Class Rule Interpretation

International Contender Class Association

Effective date: 2024-11(Nov)-19

QUESTION 1:

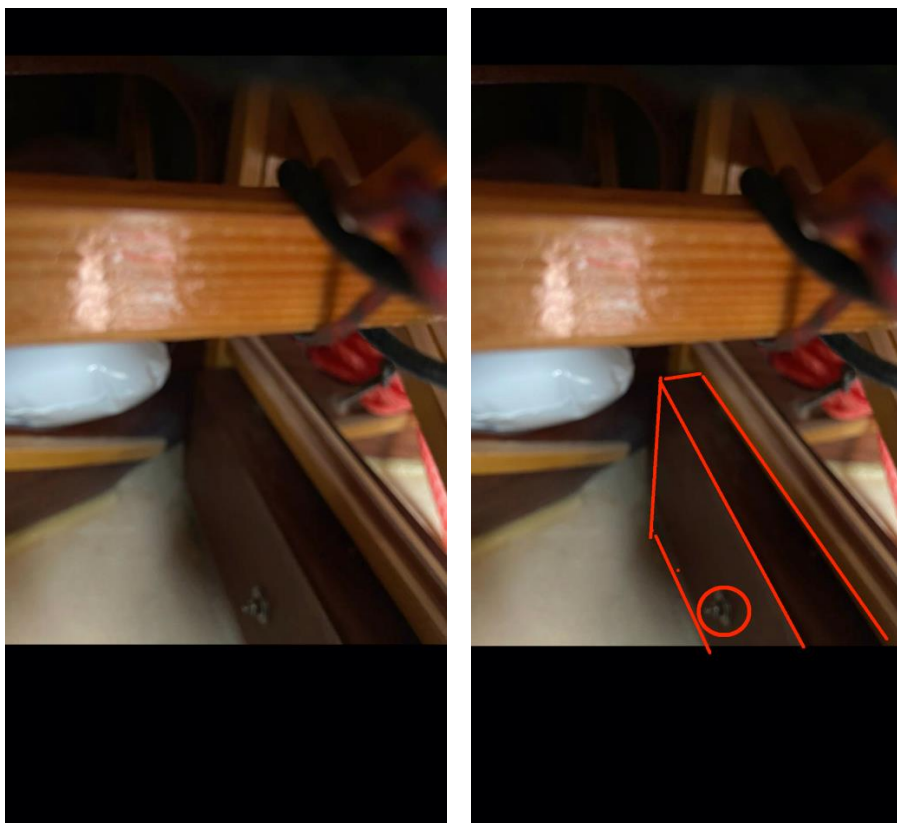
A block of wood (Dimension 5x30x12cm) added to the keelson, see picture below, secured by 1 bolt and its nut, can be considered structural? Or a corrector weight?

A block of wood is made of permitted material. It is not structural because of the connection method. It is not a corrector weight because it is not in the specified location.
